# Waukesha County

то:	State of Wisconsin-Department of Administration (Plat Review)
NOTICE OF:	Conditional Certification of No Objection to Preliminary Plat
DATE OF REVIEW:	November 17, 2020
RE:	Subdivision Plat known as: Standing Stone File No. 2040
LOCATION:	Being a redivision of Outlot 1 of Certified Survey Map No. 11932, being a part of the NW ¼, NE ¼ and the SW ¼ of Section 14, T6N, R19E, City of Waukesha
SUBMITTED BY:	State of Wisconsin-Department of Administration (Plat Review)
SURVEYOR:	Grady Gosser, Trio Engineering 4100 N. Calhoun Road, Suite 300 Brookfield, WI 53005
DATE RECEIVED:	October 28, 2020
DATE OF PLAT:	October 15, 2020
SUBDIVIDER:	Cornerstone Development of S.E. WI, LLC N63 W23849 Main Street Sussex, WI 53089
	The above subject plat has been reviewed by the staff of the Waukesha Control Department of Parks and Land Use pursuant to the provisions of Section

# PRELIMINARY PLAT **STANDING STONE**

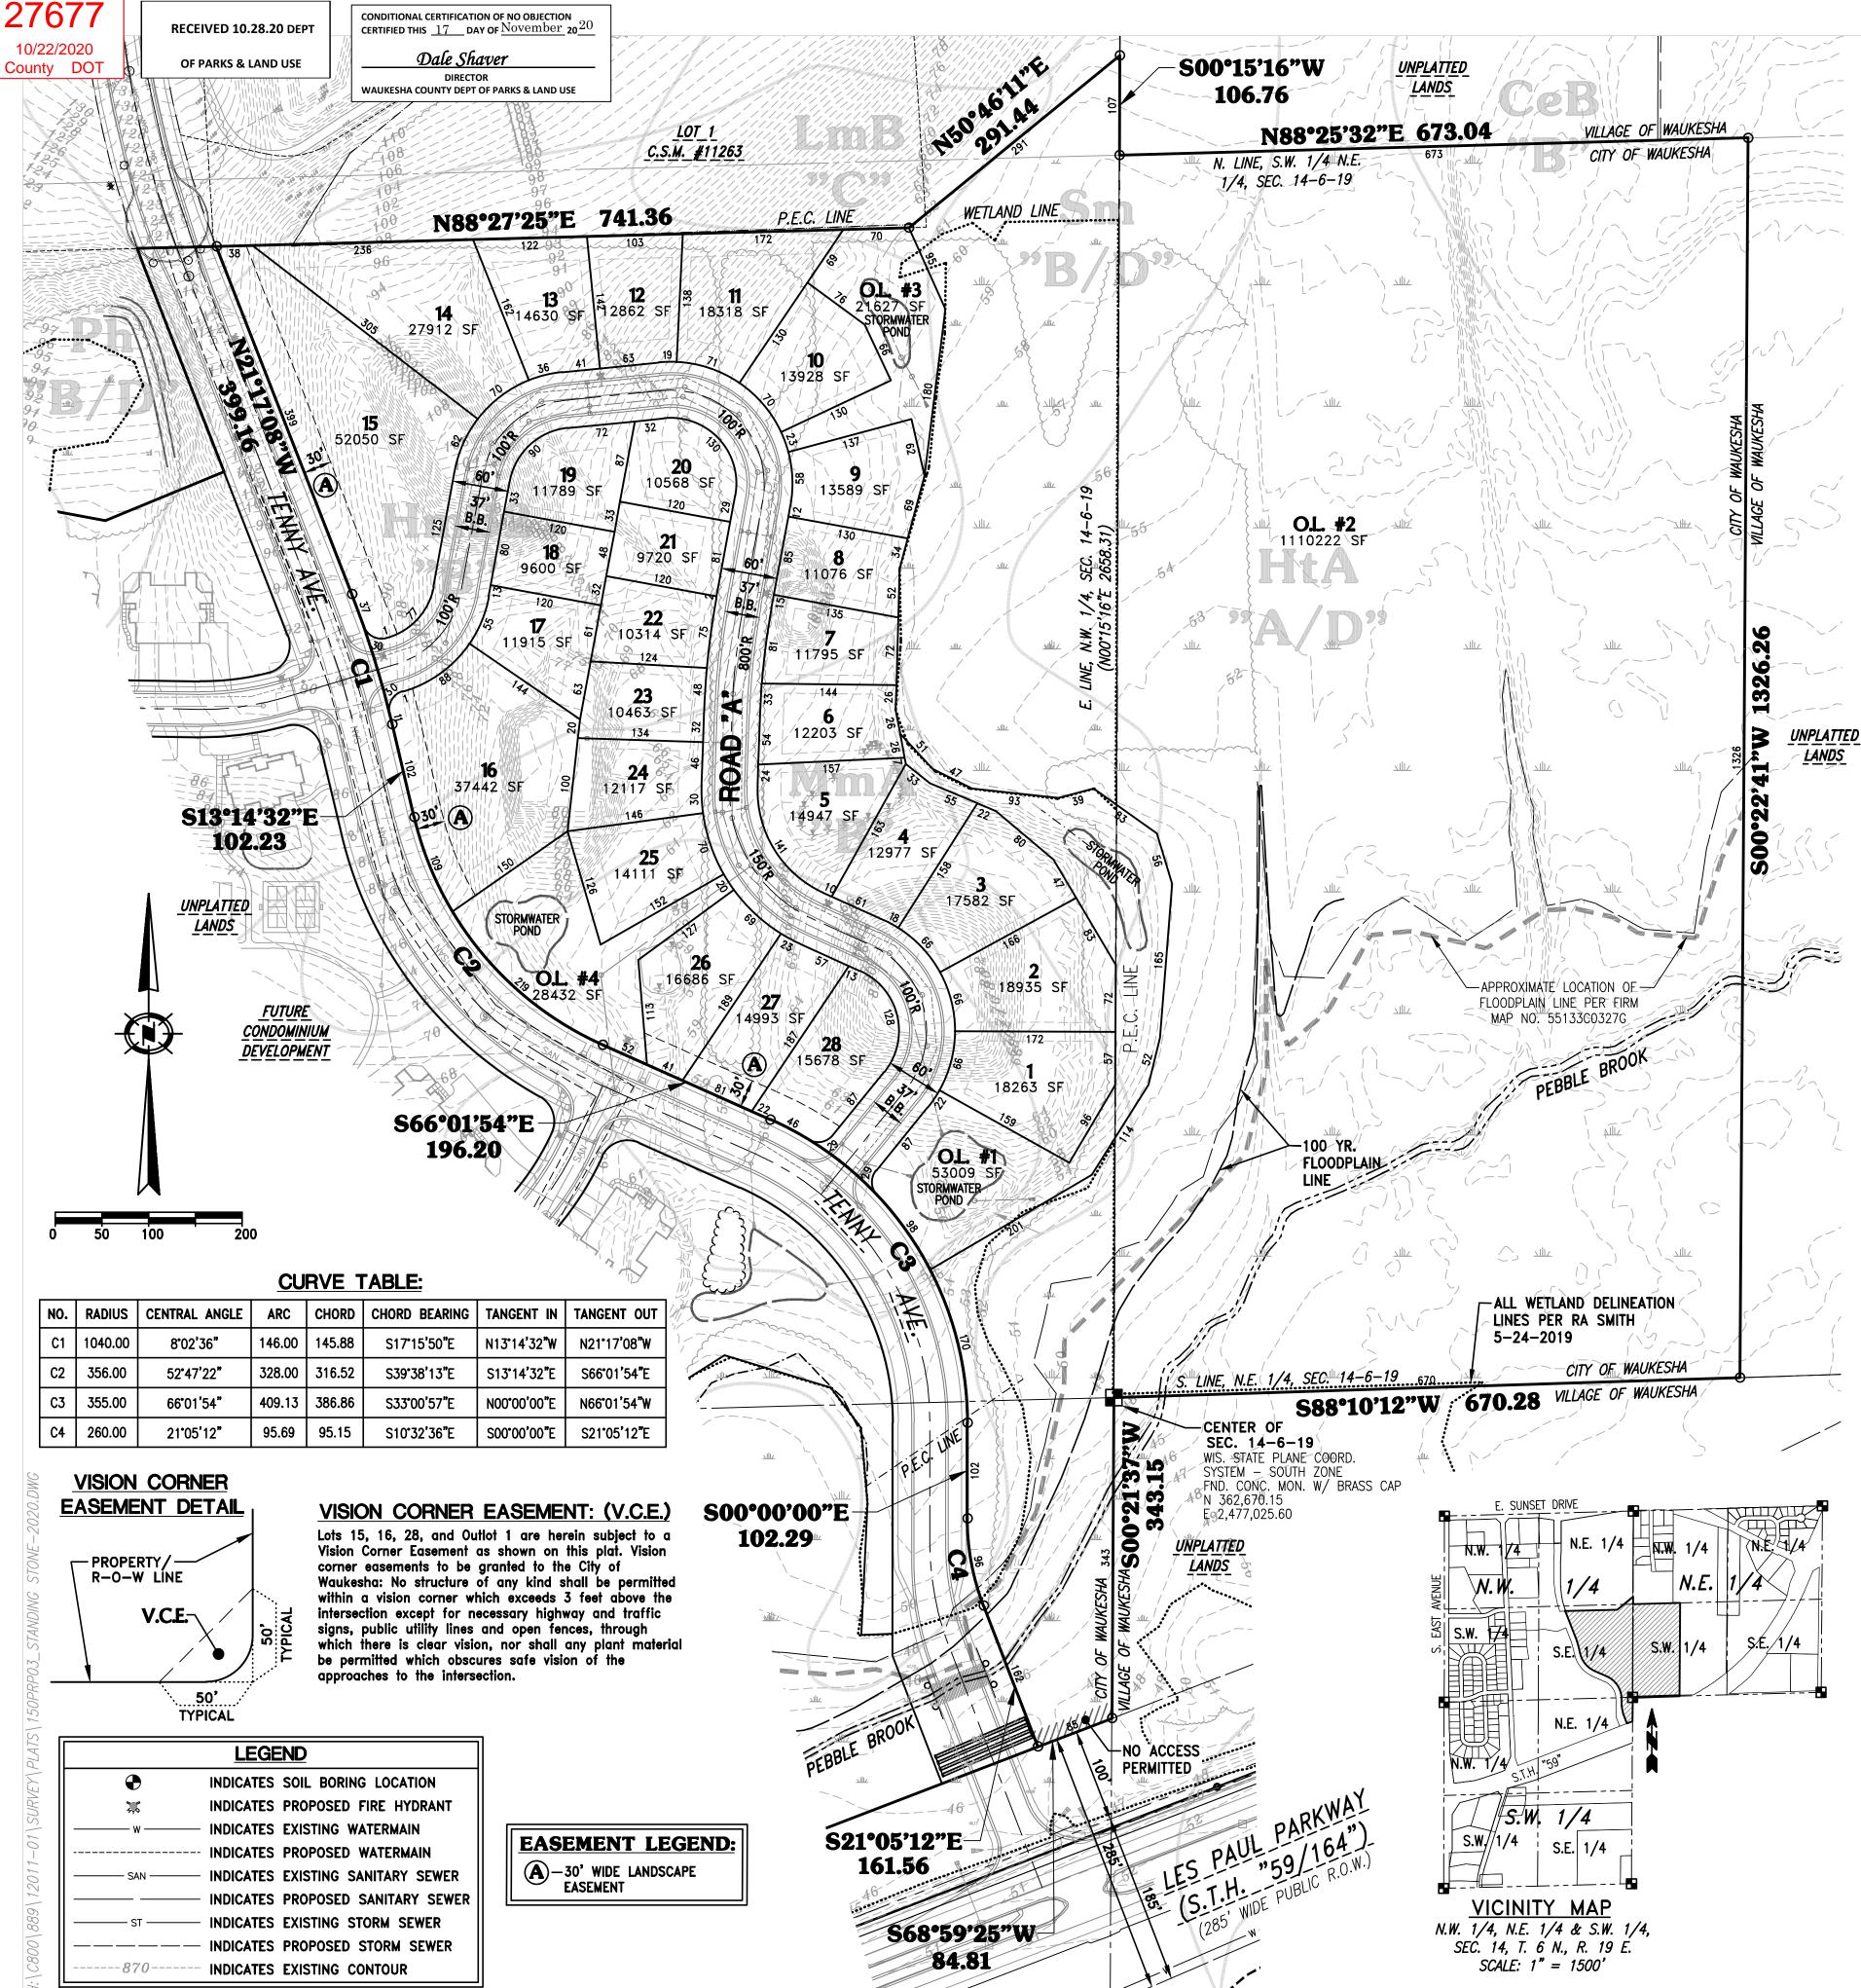
- 1. We recommend the surveyor add the written scale of 1'=100'' near the scale bar.
  - 2. The legend is missing the notation for found or placed rod or stakes. Please add if required by Chapter 236 of the Wisconsin State Statues.

- 3. All easements, such as proposed or existing drainage ways, access, sanitary sewer and utilities shall be shown on the final plat.
  - 4. The owners of the adjacent unplatted lands shall be identified on the final plat.

- 5. Any known drain tile shall be identified on the plat.
  - 6. All future roads shall be named. In addition, the right-of-way dedication shall be reflected on the final plat as "Dedicated to the Public."

- 7. Identify the width of the road right of way of Tenny Avenue.
  - 8. There appears to be some overlapping line work in relation to the floodplain, environmental corridor and wetland boundaries (approximate floodplain FIRM Map boundary/100 year floodplain; P.E.C. line not connecting, etc.). Please ensure each boundary is clearly being shown and labeled, with directional arrows added to the plat, if necessary.

- 9. If the floodplain boundary has not been field delineated, please modify the note under "Environmental Notes" to read "approximate floodplain."
  - 10. A note shall be added that states a Floodplain Study (FEMA Conditional Letter of Map Revision Case No: 19-05-4510R) has been conducted for this development that impacts the existing 1% Floodplain as identified herein.

- 11. Outlot 2 does not appear to have been a part of the wetland delineation conducted by raSmith. The Waukesha County GIS and the WDNR Surface Water Data Viewer have a majority of Outlot 2 identified as mapped wetland. The final plat must clearly show which wetlands have been delineated and field identified and which wetlands are approximate based and the source information of that determination shall be noted on the plat.

- 12. The Primary Environmental Corridor boundary shall be clearly identified and labeled as Approximate Primary Environmental Corridor per the 2015 SEWRPC records. The line work for the PEC does not appear to be present within Outlot 2.

- 13. There appear to be two streams within Outlot 2 that stem from the northern wetland complex to Pebble Creek. At a minimum, the waterways shall be identified on the plat. However, we recommend the City require that the navigability of the streams be determined by the DNR, prior to final plat submittal. If the streams are determined to be navigable, per Chapter 236, a note shall be added that states "Any land below the ordinary high water mark of a lake or a

navigable stream is subject to the public trust in navigable waters that is established under article IX, section 1, of the state constitution."

- 15. We recommend that the City verify that the standards of their stormwater management ordinance are being complied with and that any necessary notes, restrictions and easements be added to the face of the Final Plat.
- 16. Soils mapping shows some lots within this subdivision may contain soils with hydric inclusions, which are indicative of high groundwater (within 3' of the ground surface). We recommend the City require that soil borings be conducted to a depth of 1 ft. below the minimum basement floor elevations to help prevent basement flooding. The identified minimum basement floor elevations must be referenced on the final plat.
